**Re: In the Matter of PacifiCorp, dba Pacific Power, 2021 Integrated Resource Plan
(Docket No. LC 77)**

**BEFORE THE PUBLIC UTILITY COMMISSION
OF OREGON**

2021 Integrated Resource Plan

LC 77

Figure 1. Historic Henry Hub prices and PacifiCorp's IRP Natural Gas Price Forecast

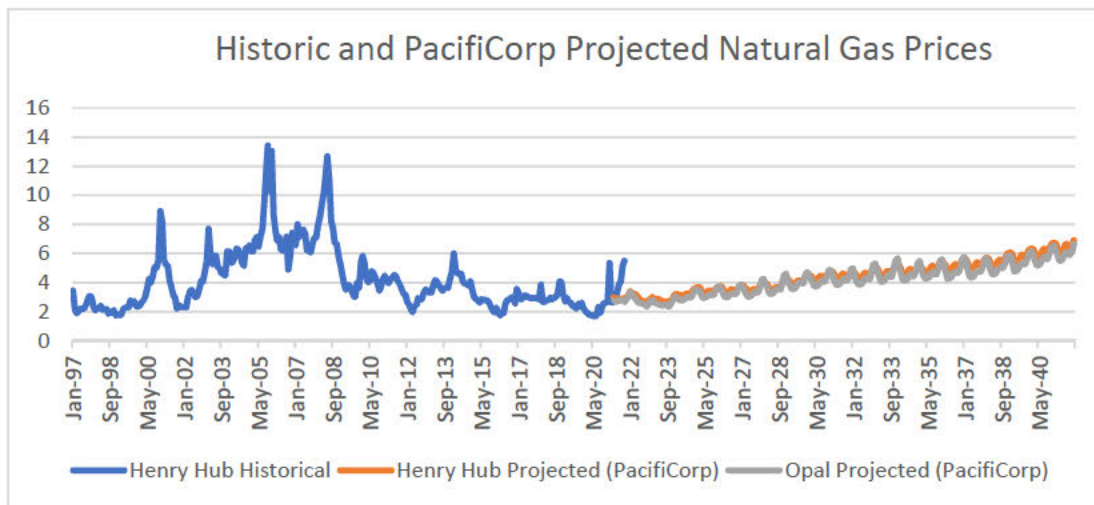
PacifiCorp's IRP forecast expects these low prices to continue for the entire planning horizon. As shown in Figure 1, PacifiCorp's forecast for Henry Hub natural gas prices begins in April 2021 at just under \$3/MMBtu, slowly rise to \$4 in 2029, \$5 in 2034, and ultimately top off at just under \$7/MMBtu by 2041.⁶⁴

However, gas prices have nearly doubled in the past year alone.⁶⁵ Prices rose sharply in February 2021 after the Texas winter storm, dropped quickly, but then immediately started a persistent climb in March 2021 until today. Because PacifiCorp had to lock in its gas price forecast as an input for its IRP in early 2021, we can track the Company's forecast to actual gas prices. Since

Figure 2. Henry Hub Prices Since January 2020, and PacifiCorp's Gas Price Forecast

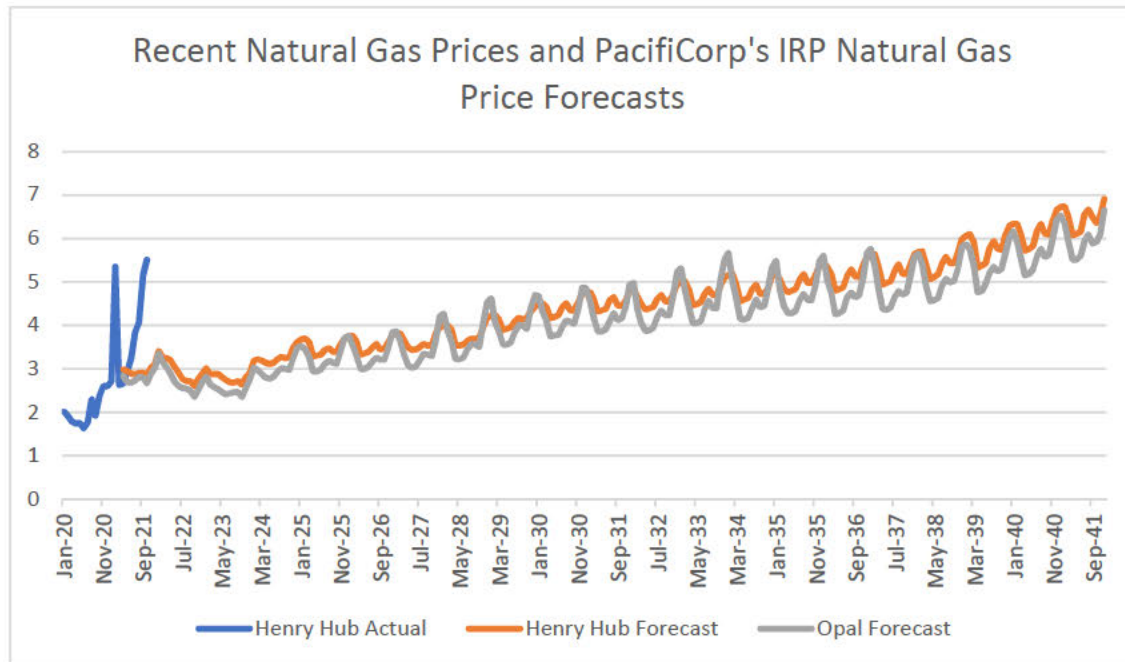
April 2021, actual gas prices have significantly increased relative to the Company’s forecast. In October 2021, the Henry Hub price for gas was \$5.51/MMBtu, nearly double the Company’s forecast of \$2.84/MMBtu.

This year’s dramatic increase in gas prices may be a relative blip and prices could decline once again; however, there is also a real chance high prices could persist as a “new normal.”

- *Recommendation 13*: The Commission should require PacifiCorp to provide updated risk assessment of gas fuel that reflects recent price trends. This assessment should be provided as a condition of beginning any construction on the Jim Bridger conversions.

Figure 3. U.S. Natural Gas Production

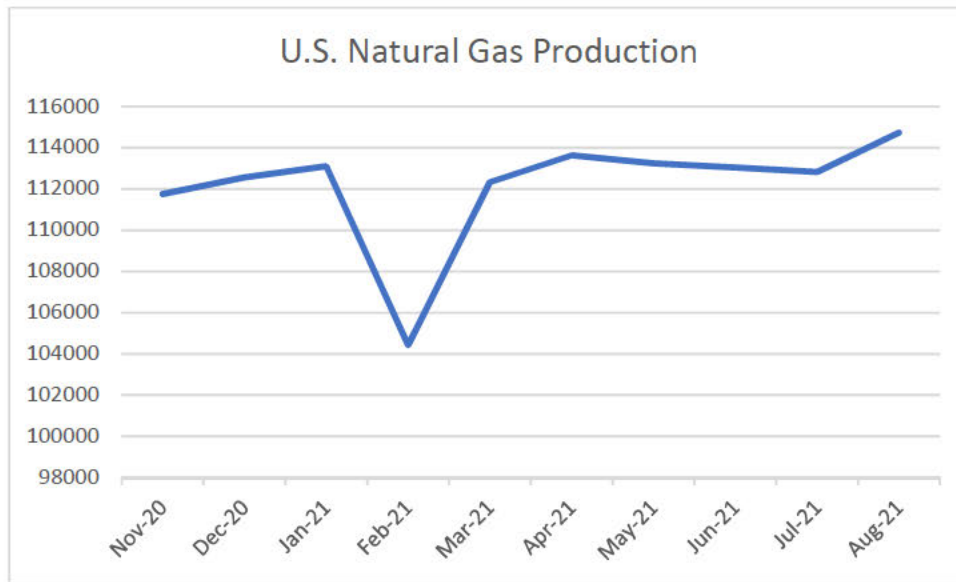
The domestic and international gas markets continue to evolve. European and Asian gas prices are higher than normal as demand outpaces supplies.⁶⁹ The United States is not immune to this global dynamic and, in fact, has much more international exposure now due to LNG expansion.⁷⁰ The cost of financing new fossil fuel projects, like fracked gas wells, and the distribution system for carrying that gas, is increasingly costly relative to alternative opportunities, like renewable generation.⁷¹ Fossil fuel company shareholders are demanding higher returns after a decade of relatively low growth of returns.⁷²
